Item No. 16 SP 2/2018 – Proposed Secondary Plan for Precinct ‘G’ of the Complete Communities Direction Strategy – First Reading (Old Kildonan Ward)

Title: SP 2/2018 – Proposed Secondary Plan for Precinct ‘G’ of the *Complete Communities Direction Strategy* – First Reading

APPENDIX 'A' – Planning Discussion

FILE: SP 2/2018 (By-law 5/2018)

Figure 14 –Transportation Map (Revised)

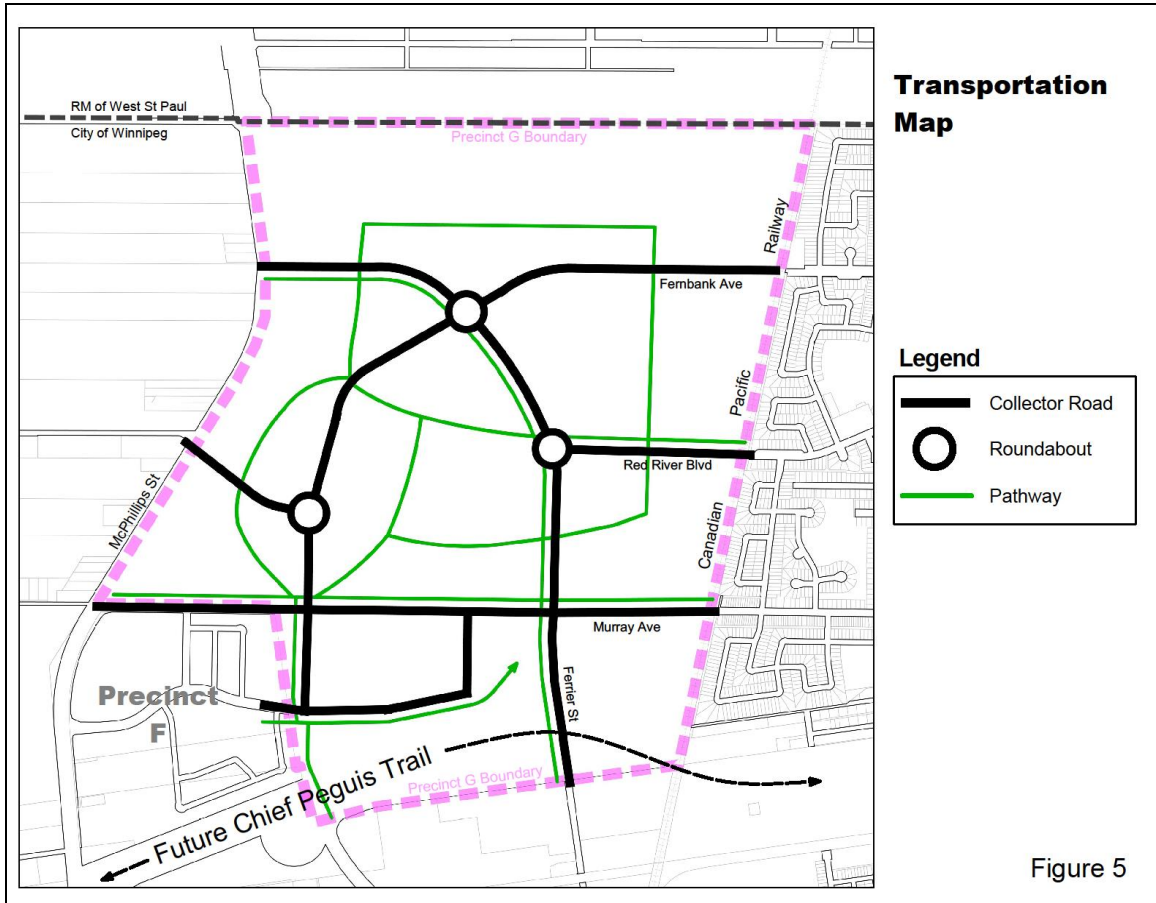
Rationale: The recommended map includes updates to the pathway and eliminates the potential closing of the crossing at Murray Avenue. The closing of the crossing at Murray Avenue is not supported by the Transportation Study.

Change: That, Figure 5 “*Transportation Map*” of the proposed Plan be deleted and replaced with Figure 5: “*Transportation Map*” as presented in Figure 14 – *Transportation Map (Revised)* of this Planning Discussion.
